RESPONSE TO
U.S. NUCLEAR REGULATORY COMMISSION
LETTER LS05-83-C5-067 DATED
MAY 27, 1983 TO MR. P. B. FIEDLER
OYSTER CREEK
NUCLEAR GENERATING STATION

General Public Utilities Nuclear
Parsippany, New Jersey

August 1983

FIGURE 1 - POWER SPECTRAL DENSITY -
TWO VALVES - COLD PIPE

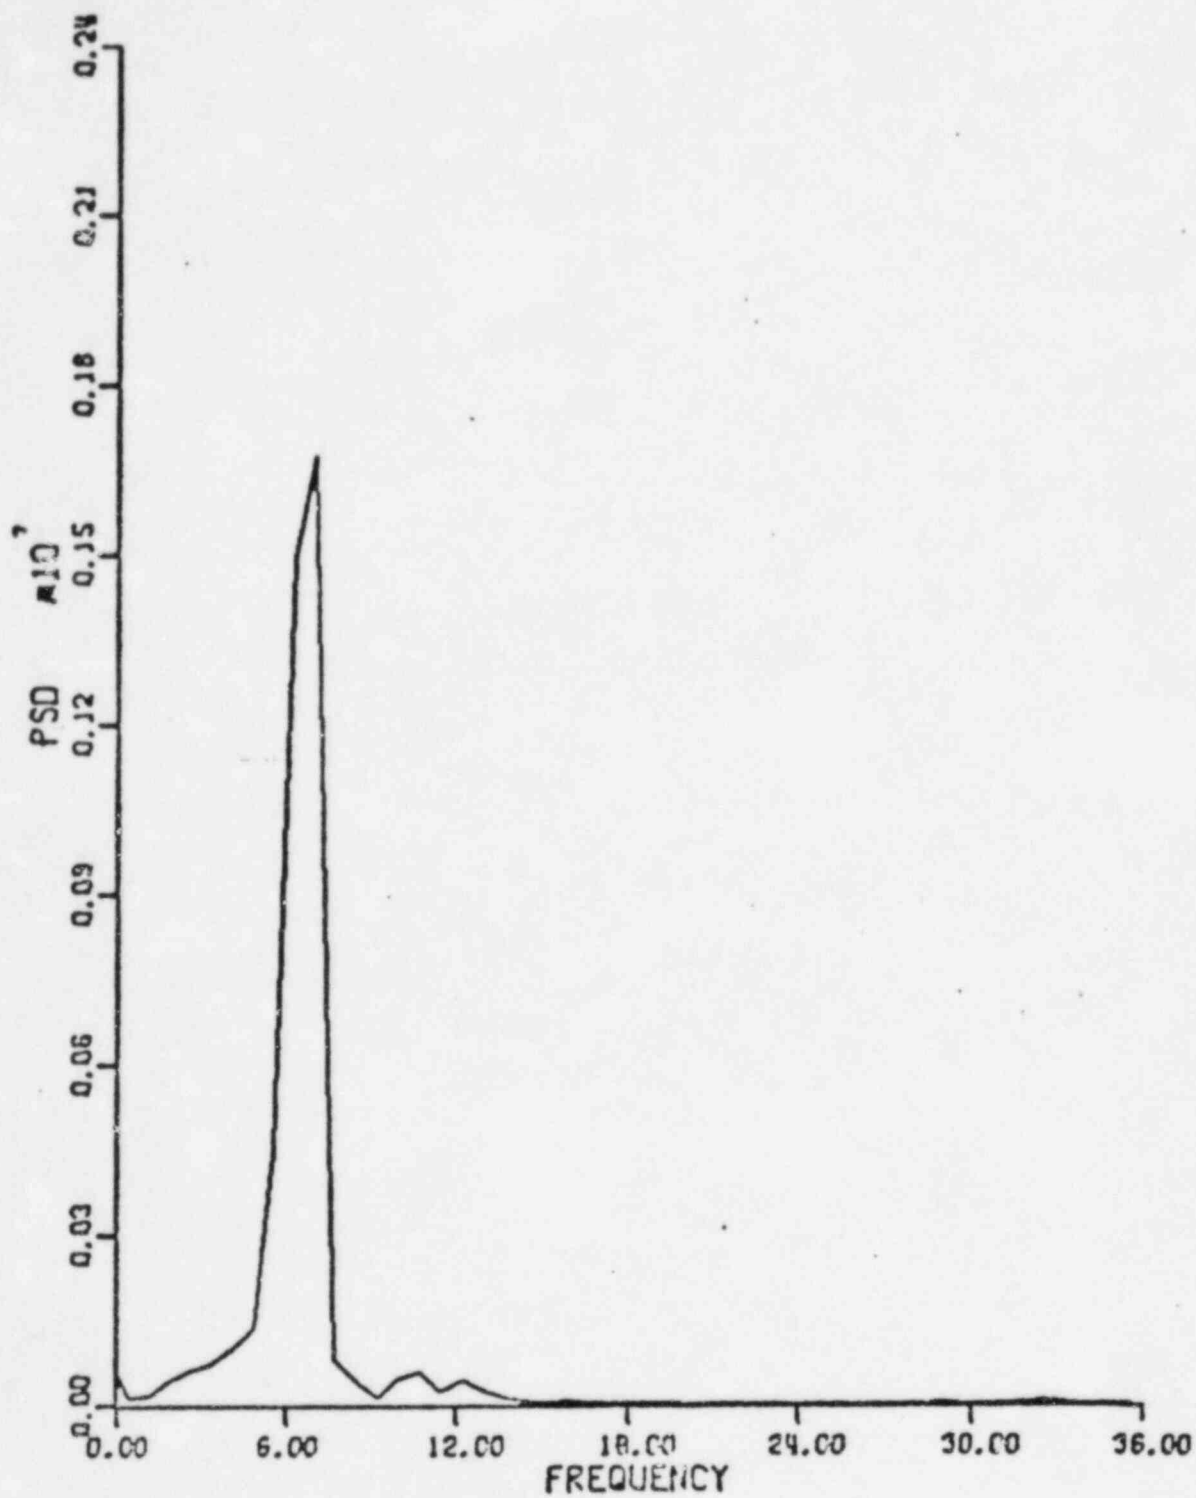
Additional information was requested about the pressures measured by transducers mounted on the inside wetted surface of the torus shell during the electromatic relief valve (ERV) actuation tests discussed in Reference 3.2. In particular, power spectral density (PSD) plots were requested from pressure time-history data recorded by the transducer experiencing the largest pressure excursions.

Figure 1 - Two valves open with the ERV line cold. The bubble time history represented by this PSD was used as the reference for SRV-related dynamic analysis of the torus.
